Project	<b>IEEE 802.16 Broadband Wireless Access Working Group</b> < <a href="http://ieee802.org/16">http://ieee802.org/16</a> >
Title	<b>Correction of U-TDOA Measurement Procedure</b>
Date Submitted	<b>2007-01-04</b>
Source(s)	Jaesun Cha, Kwangjae Lim, and, Chulsik Yoon <a href="mailto:jscha@etri.re.kr">jscha@etri.re.kr</a> ETRI 161 Gajeong-dong, Yuseong-gu Daejeon 305-700 Korea
Re:	Contribution on comments to IEEE 802.16g/D6
Abstract	Correction of U-TDOA Measurement Procedure
Purpose	Adoption
Notice	This document has been prepared to assist IEEE 802.16. It is offered as a basis for discussion and is not binding on the contributing individual(s) or organization(s). The material in this document is subject to change in form and content after further study. The contributor(s) reserve(s) the right to add, amend or withdraw material contained herein.
Release	The contributor grants a free, irrevocable license to the IEEE to incorporate text contained in this contribution, and any modifications thereof, in the creation of an IEEE Standards publication; to copyright in the IEEE's name any IEEE Standards publication even though it may include portions of this contribution; and at the IEEE

Figure G3 – UTDOA Measurement Algorithm

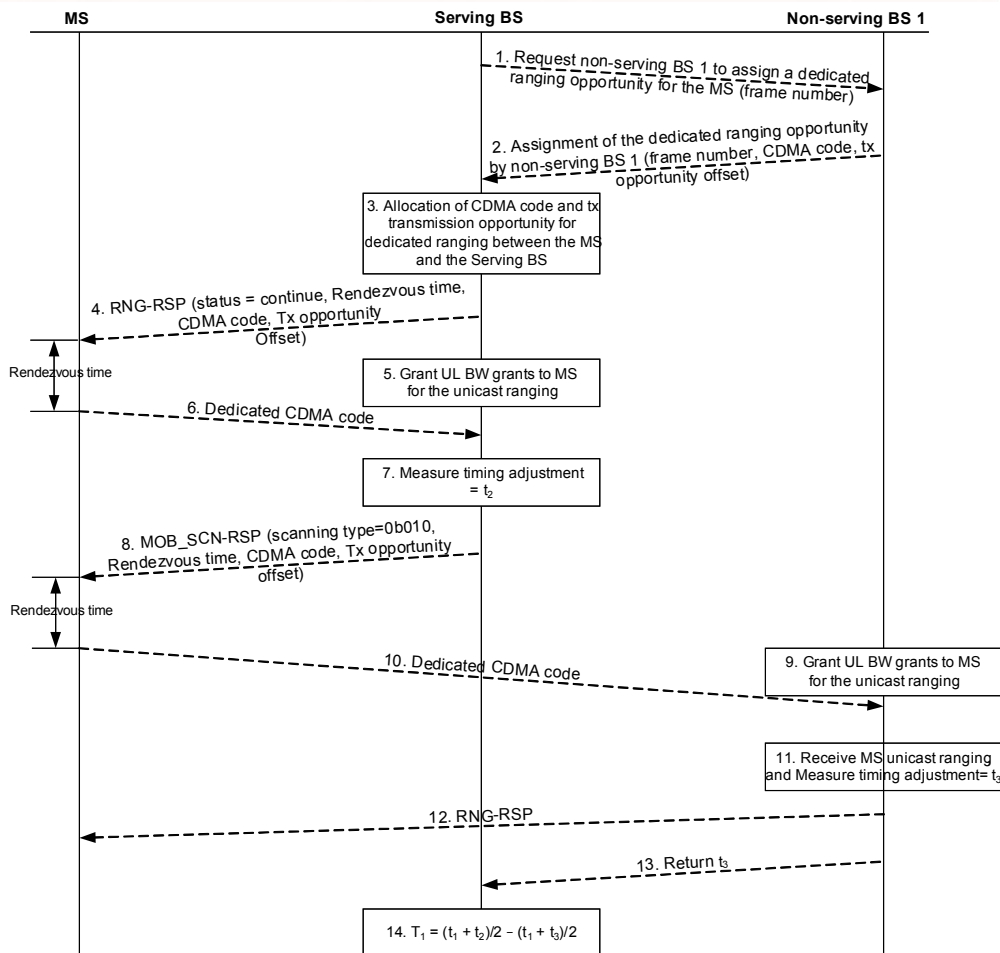
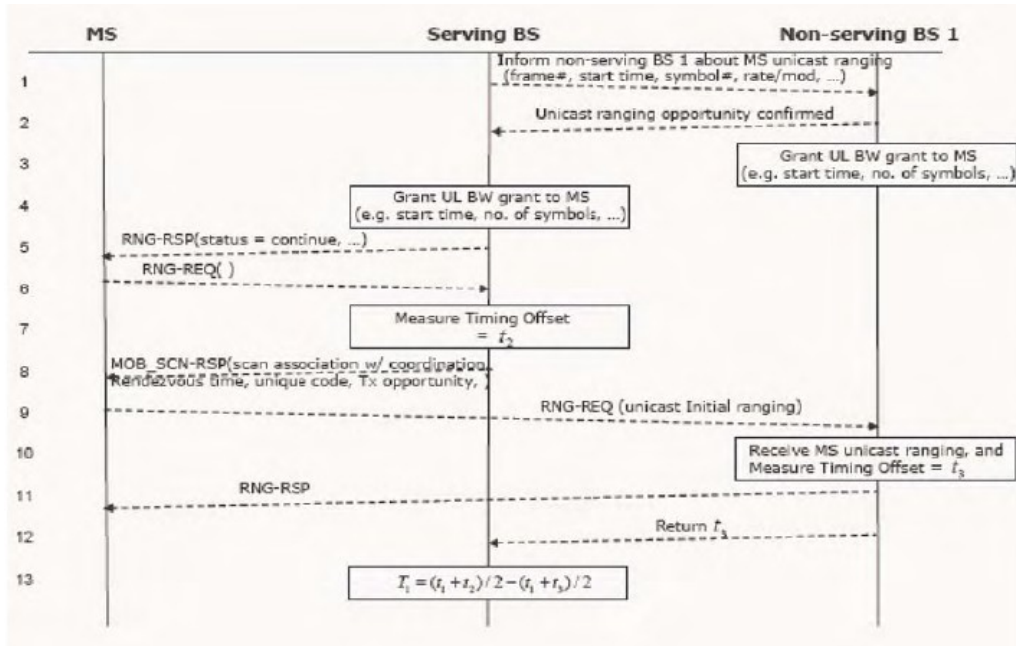
5. ~~Serving BS sends an autonomous RNG-RSP message to ask MS performing unicast ranging~~
6. ~~When MS receives the RNG-RSP from serving BS, it shall send RNG-REQ at the assigned slot~~

7. ~~Serving BS 1 measures Timing Adjustment  $t_2$~~
8. ~~Serving BS sends autonomous MON\_SCN-RSP with scanning type = 0b10 (scan association with coordination) to force MS performing initial ranging after scan~~

9. ~~MS synchronized with non-serving BS 1, and sends RNG-REQ~~
10. ~~Non-serving BS 1 receives unicast ranging, and measures Timing Adjustment  $t_2$~~

11. ~~Non-serving BS returns RNG-RSP to MS~~
12. ~~Non-serving BS returns  $t_2$  to serving BS~~
13. ~~Serving BS reads the Timing Advance  $t_1$  that was captured previously, and calculate U-TDOA~~

1. Serving BS requests non-serving BS 1 to assign the dedicated ranging opportunity for the MS.
  2. Non-serving BS 1 confirms the allocation of the dedicated ranging opportunity for the MS and returns the related parameters used for dedicated ranging between the MS and the non-serving BS 1.

- Frame Number
    - CDMA code
    - Transmission opportunity offset
  3. Serving BS allocates a CDMA code and transmission opportunity for dedicated ranging between the MS and the Serving BS.

4. Serving BS sends an autonomous RNG-RSP message to ask MS performing dedicated ranging. The dedicated ranging information for dedicated ranging between the MS and the Serving BS is included in RNG-RSP message.

- Rendezvous time
    - CDMA code
    - Transmission opportunity offset
  5. Serving BS allocates a UL slot for MS to do dedicated ranging which means “dedicated ranging indicator” bit of the UL-MAP IE shall be set to 1.

6. After the rendezvous time from the reception of the RNG-RSP message, MS sends the CDMA code assigned in the RNG-RSP message at the allocated transmission opportunity offset.

7. Serving BS measures Timing Adjustment  $t_2$
  8. Serving BS sends autonomous MOB\_SCN-RSP with scanning type = 0b10 (scan association with coordination) to force MS performing initial ranging after scan. The related parameters assigned by non-serving BS 1 are included in the MOB\_SCN-RSP message.

- Rendezvous time
    - CDMA code
    - Transmission opportunity offset
  9. Non-serving BS 1 grants UL slot to the MS and sets “dedicated ranging indicator” bit of the UL-MAP IE to 1 to use the allocated region for the purpose of dedicated ranging.

10. After the rendezvous time from the reception of the MOB\_SCN-RSP, MS synchronized with non-serving BS 1, and sends the allocated CDMA code at the allocated transmission opportunity offset.

11. Non-serving BS 1 receives the assigned CDMA code, and measures Timing Adjustment  $t_3$ .
  12. Non-serving BS 1 returns RNG-RSP to MS
  13. Non-serving BS 1 returns  $t_3$  to serving BS

14. Serving BS reads the Timing Advance  $t_1$  that was captured previously, and calculate U-TDOA

Figure G5 – U-TDOA Measurement Algorithm

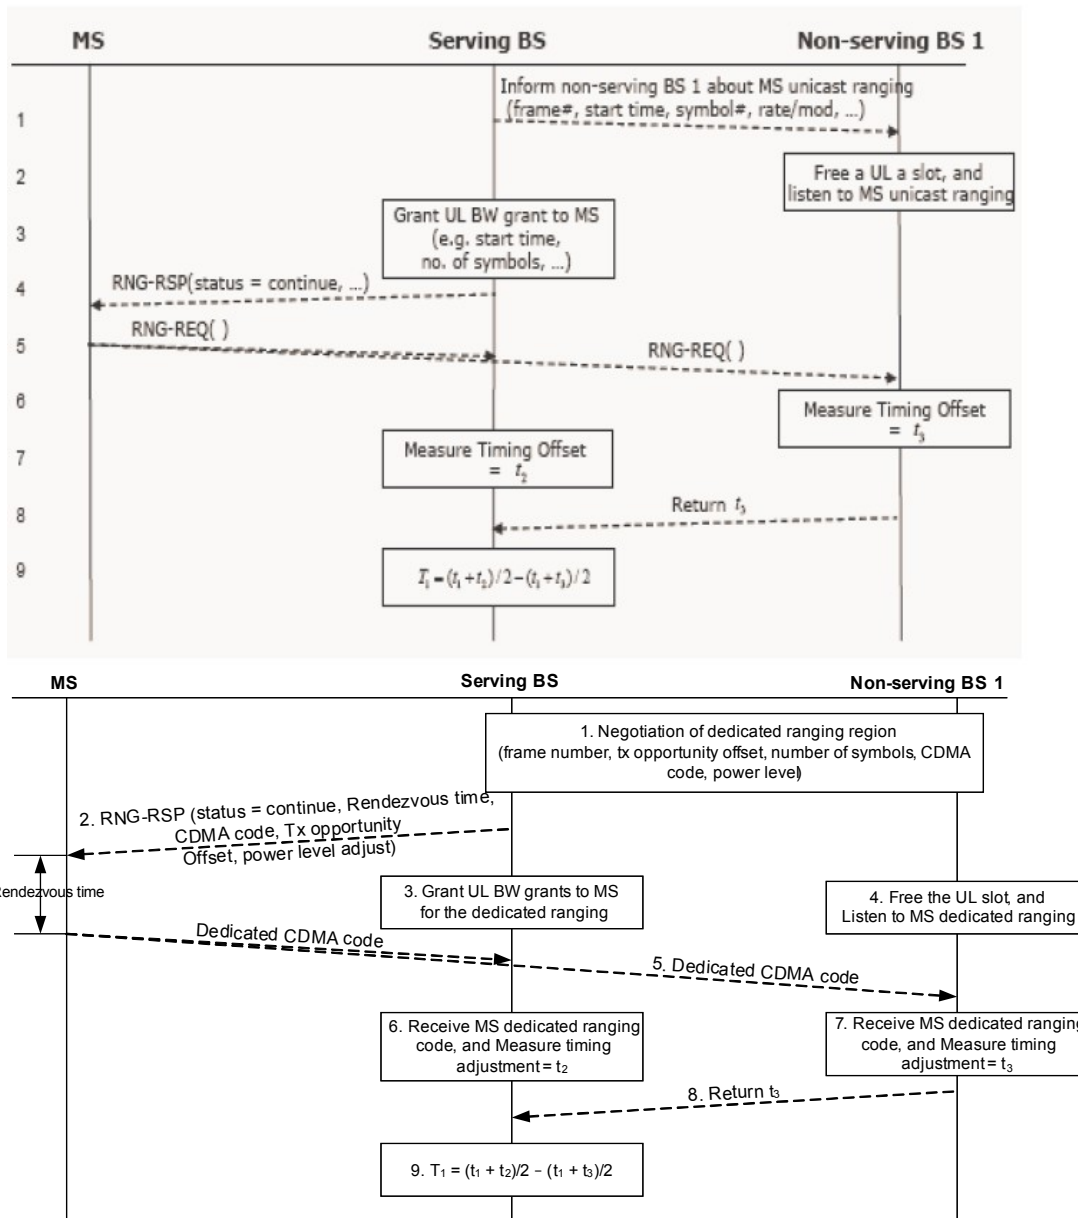
1. Serving BS informs non-serving BS 1 about MS is going to do unicast ranging by passing frame number, start time, number of symbols,
  2. Non-serving BS 1 does not grant such UL slot to the MS, and listens to the unicast ranging from MS

3. Serving BS allocates a UL slot for MS to do unicast ranging.
  4. Serving BS sends an autonomous RNG-RSP message to ask MS performing unicast ranging

5. When MS receives the RNG-RSP from serving BS, it shall send RNG-REQ at the assigned slot that can be received by non-serving BS.
  6. Non-serving BS 1 measures Timing Adjustment  $t_3$ .

7. Serving BS measures Timing Adjustment  $t_2$
  8. Non-serving BS 1 returns  $t_3$  to serving BS
  9. Serving BS reads the Timing Advance that was captured previously, and calculates U-TDOA

1. Serving BS and non-serving BS 1 negotiate the allocation of a dedicated ranging region for the MS.
    - Frame Number
    - Transmission opportunity offset

- Number of Symbols
  - CDMA code
  - Power Level
2. The serving BS sends an unsolicited RNG-RSP message to ask MS performing the dedicated ranging. The dedicated ranging information is included in the RNG-RSP message.

- Rendezvous time
    - CDMA code
    - Transmission opportunity offset
  3. The serving BS allocates a UL slot for MS to do dedicated ranging at the pre-assigned rendezvous time and listens to the dedicated ranging code from the MS.

4. At the same time, the non-serving BS 1 does not grant such UL slot to any MSs at the pre-assigned rendezvous time and listens to the dedicated ranging code from the MS.

5. When the MS receives the unsolicited RNG-RSP from the serving BS, it shall send the dedicated CDMA code at the assigned slot. The transmission power shall be changed based on the power level adjust parameter included in the receive RNG-RSP message to allow the non-serving BS to receive the code successfully.

6. The non-serving BS 1 measures Timing Adjustment  $t_3$
  7. The serving BS measures Timing Adjustment  $t_2$
  8. The non-serving BS 1 returns  $t_3$  to serving BS

9. The serving BS reads the Timing Advance that was captured previously, and calculates U-TDOA
